ADDENDUM NO. 5

Reference: New Classroom Building
UVU - Orem, Utah
DFCM Project No. 12192790

ADDENDUM NO. 5
May 22nd, 2013

Utah Valley University Classroom Building
Orem, Utah

A1 SB101A Footing & Foundation Plan Area 'A'

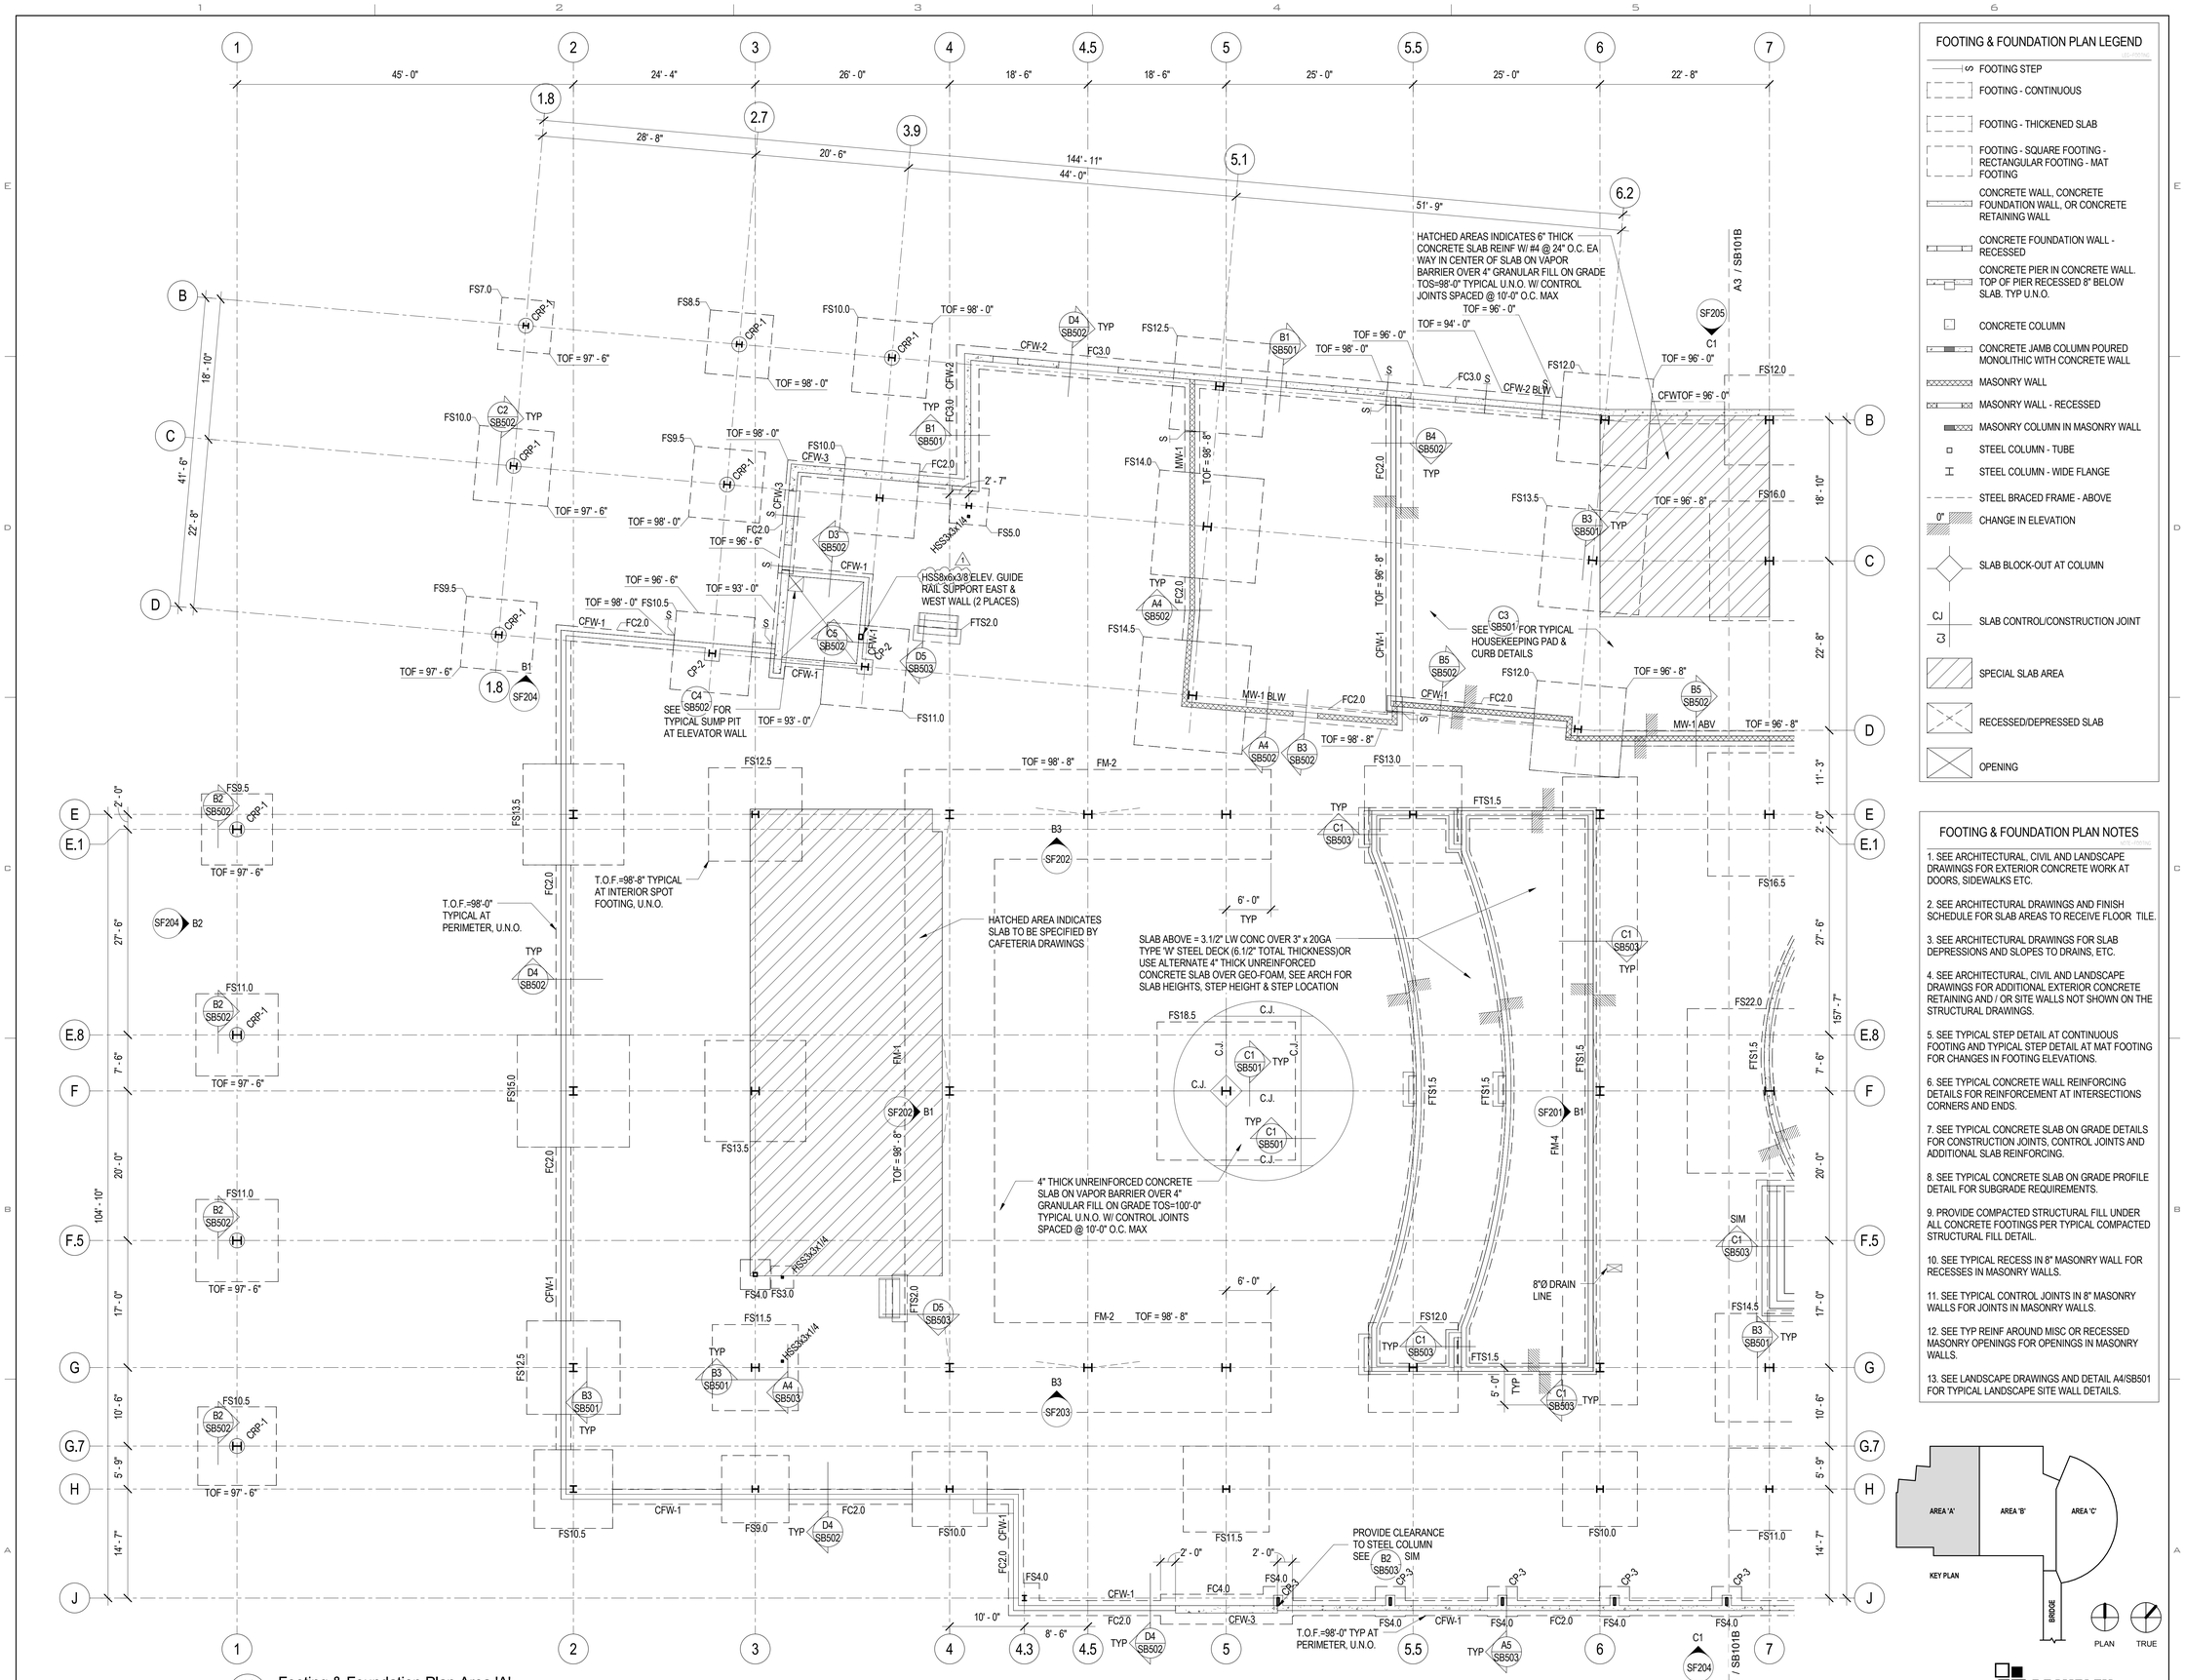
Sheet SB101A
1. Add elevator guide rail support column size. See revised Sheet SB101A.

A3 / SB101B Footing & Foundation Plan Area 'B'

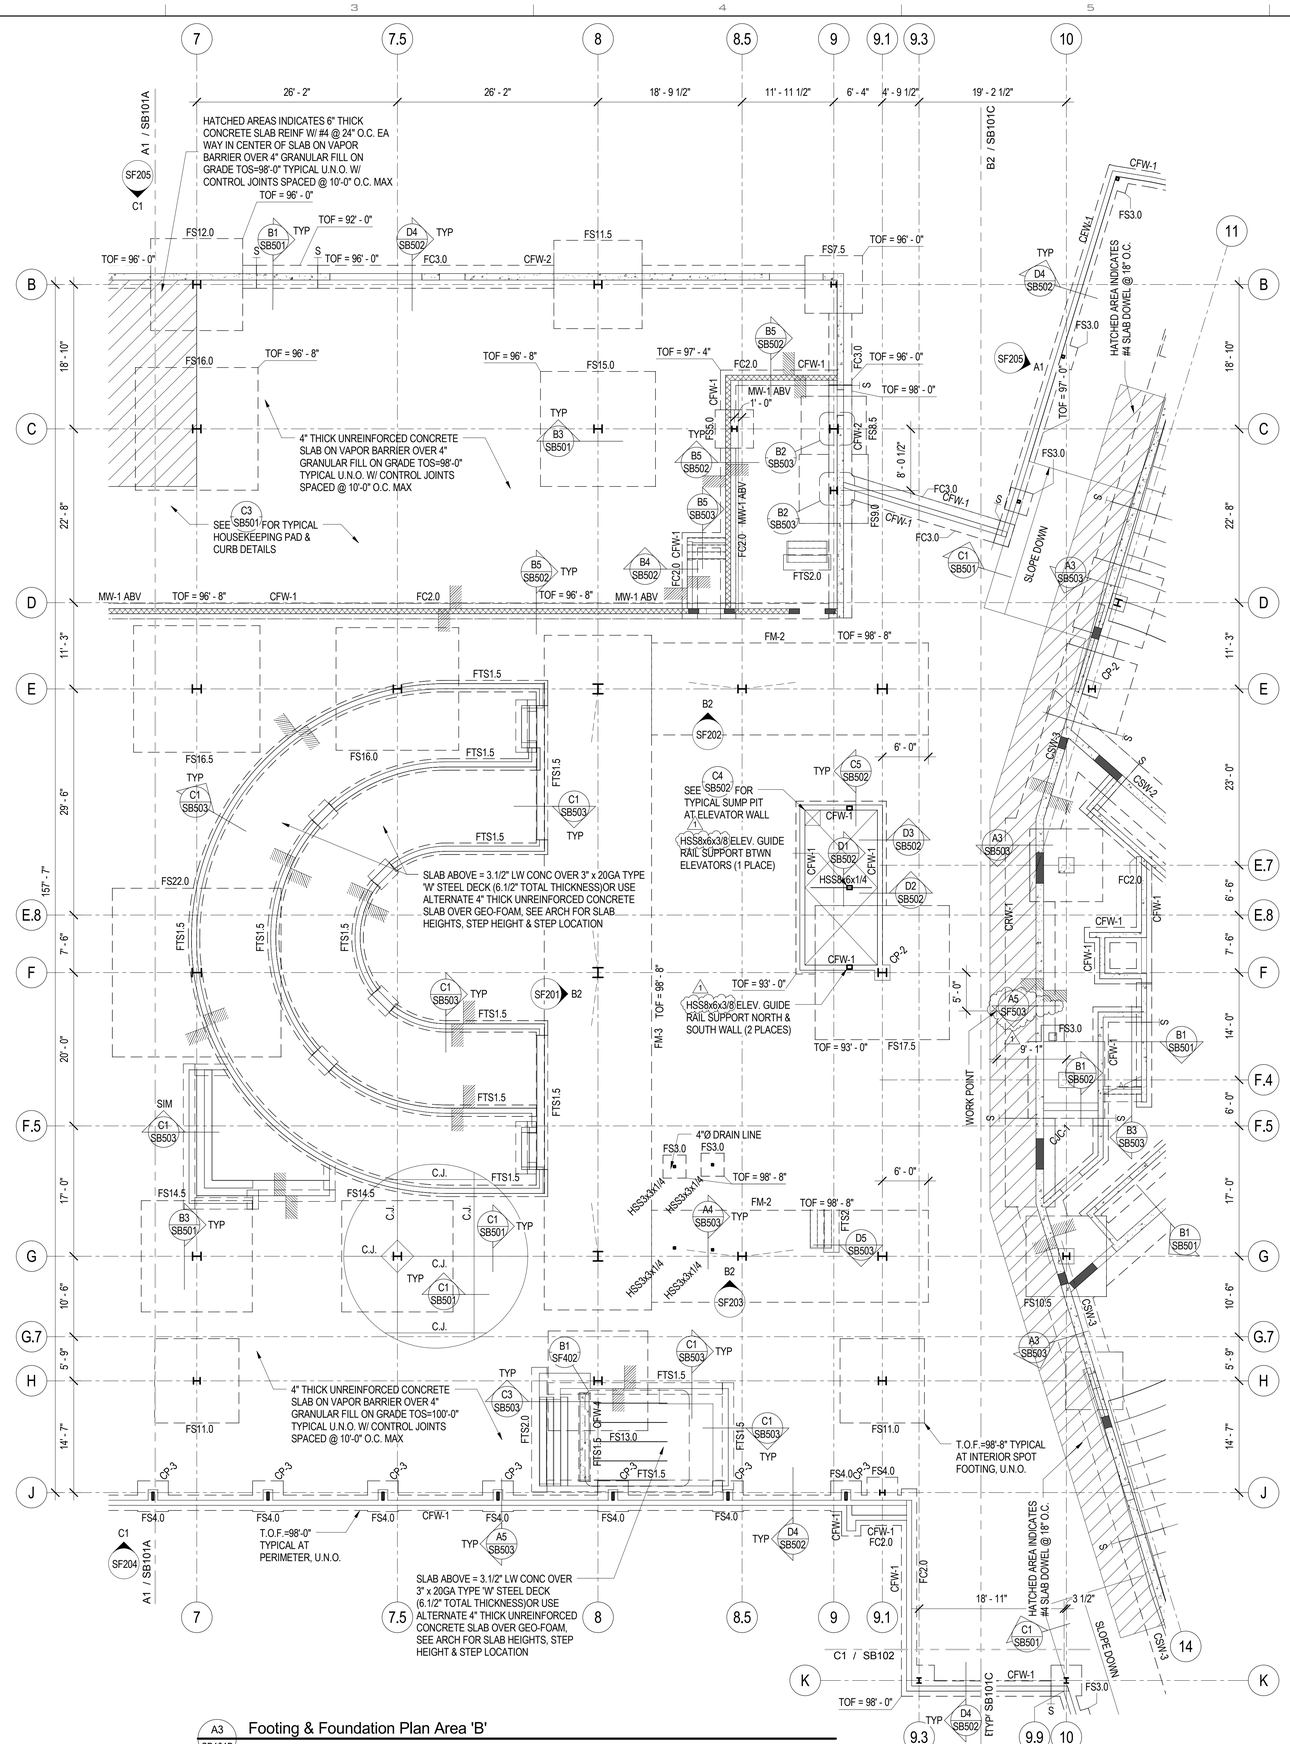
Sheet SB101B
1. Add elevator guide rail support column size. See revised Sheet SB101B.

B2 SB101C Footing & Foundation Plan Area 'C'

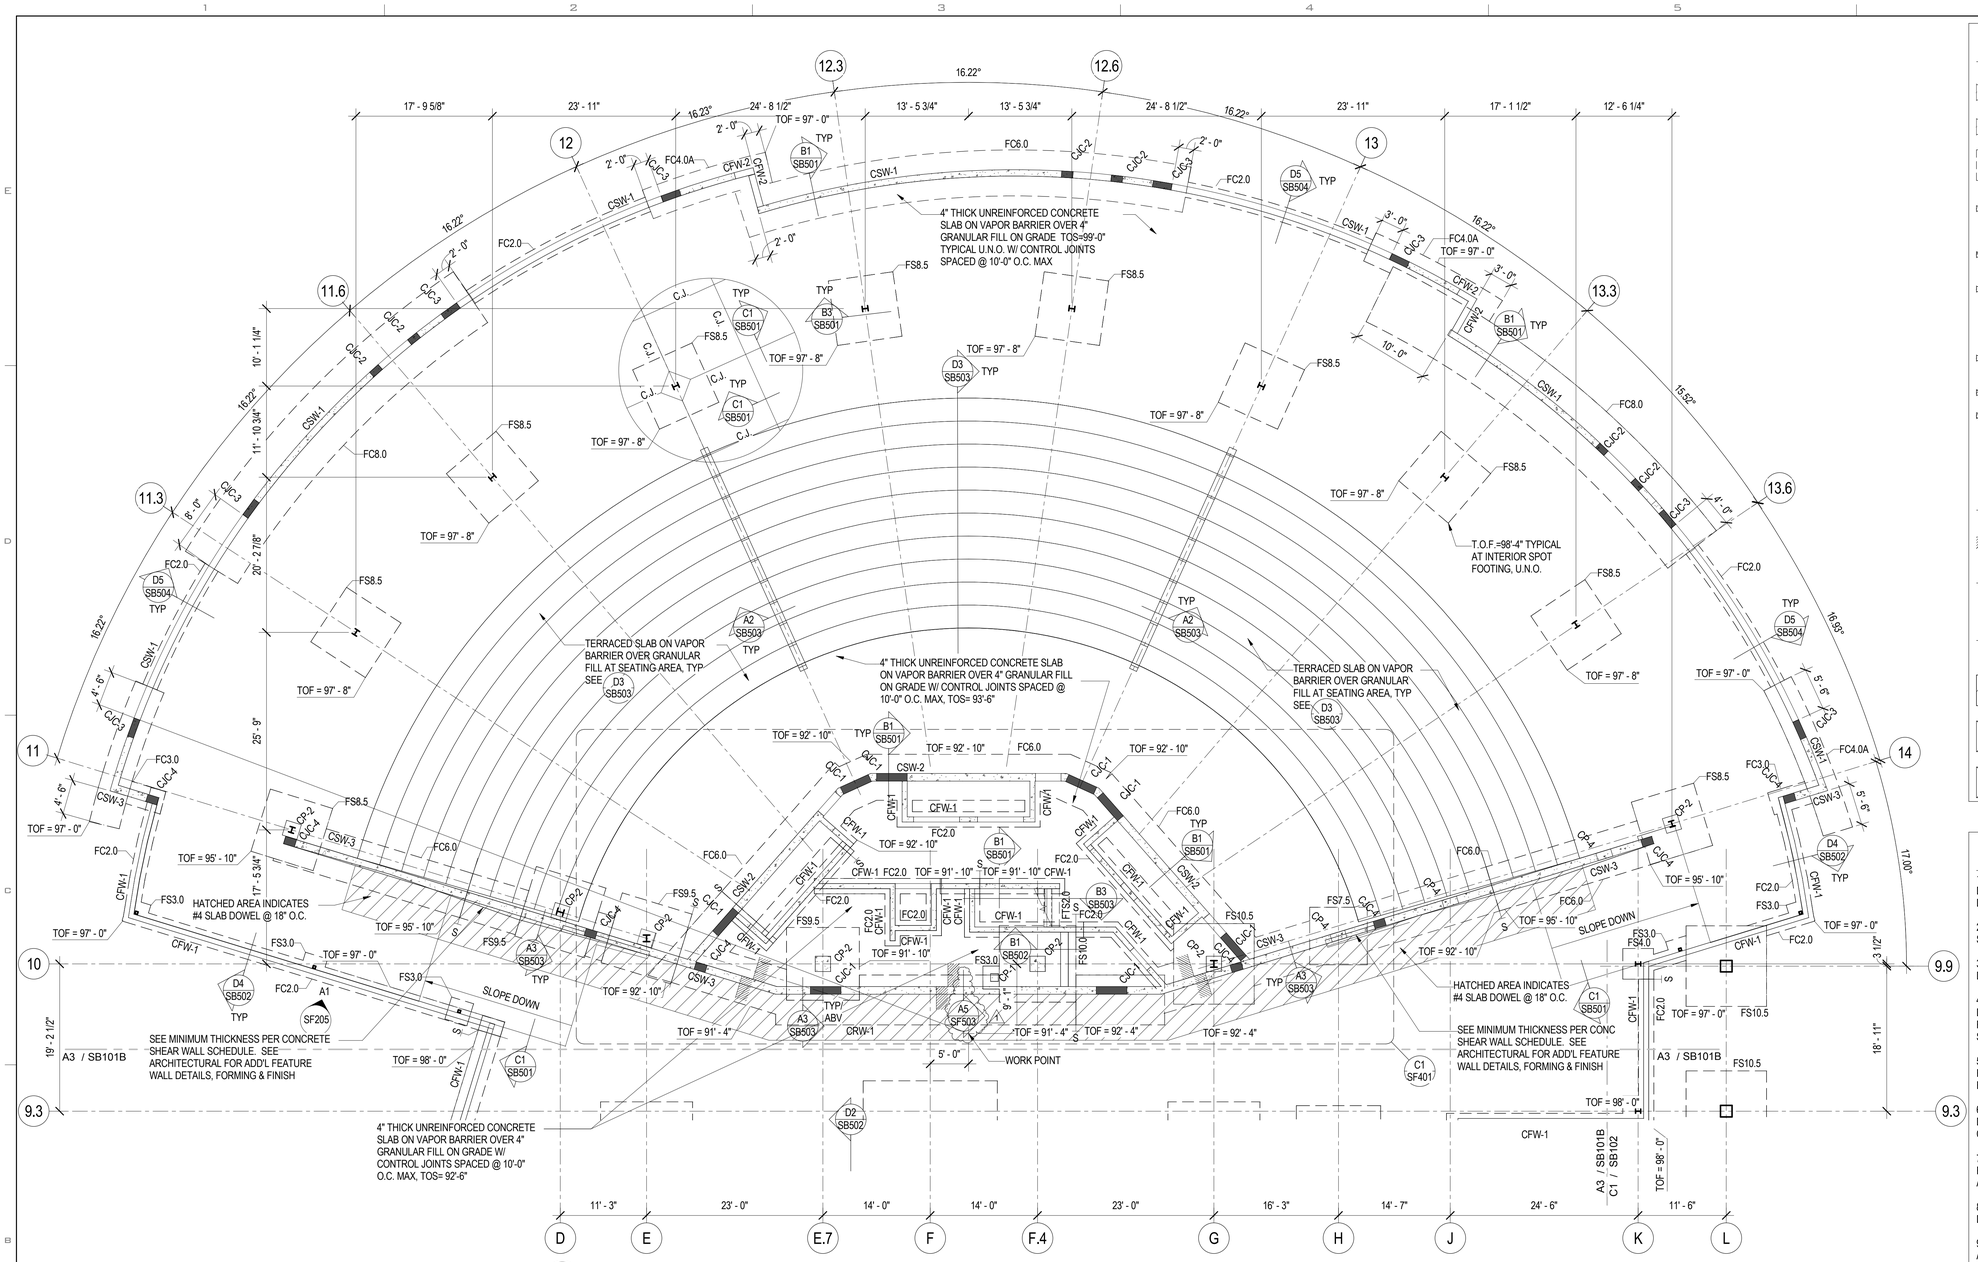
Sheet SB101C
1. Add detail cut A5/SF503 at bench at opening in concrete wall near Grid 10 and between Grids F and F.4. See revised Sheet SB101C.

D1 SF101 Bridge Roof Framing Plan

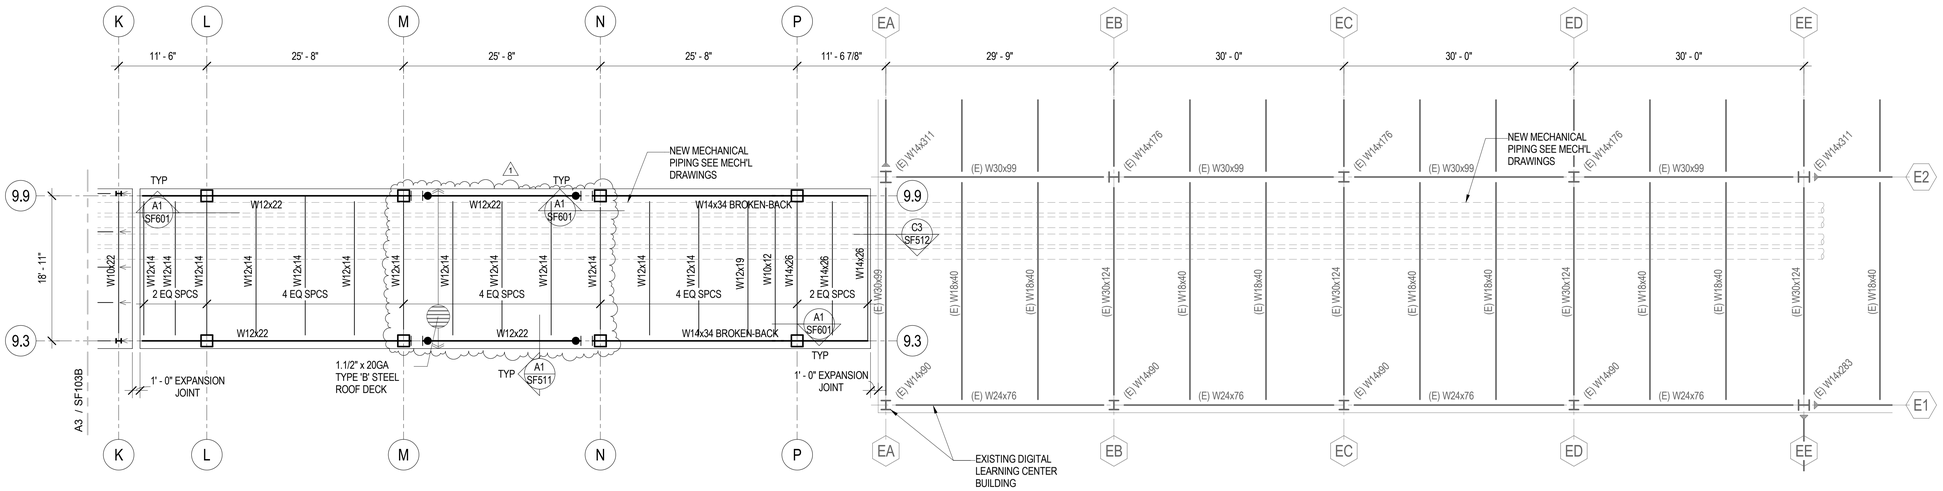
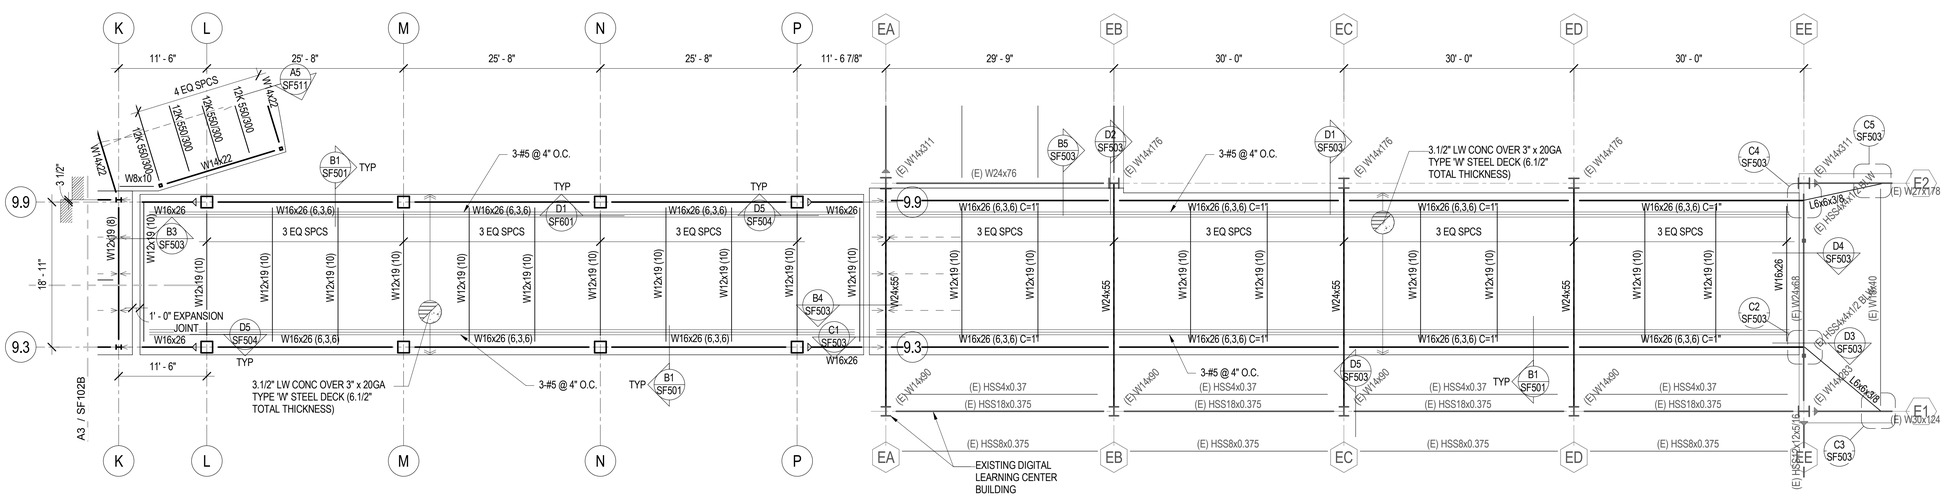
Sheet SF101
1. Revise bridge roof framing connections on D1/SF101. See revised Sheet SF101.
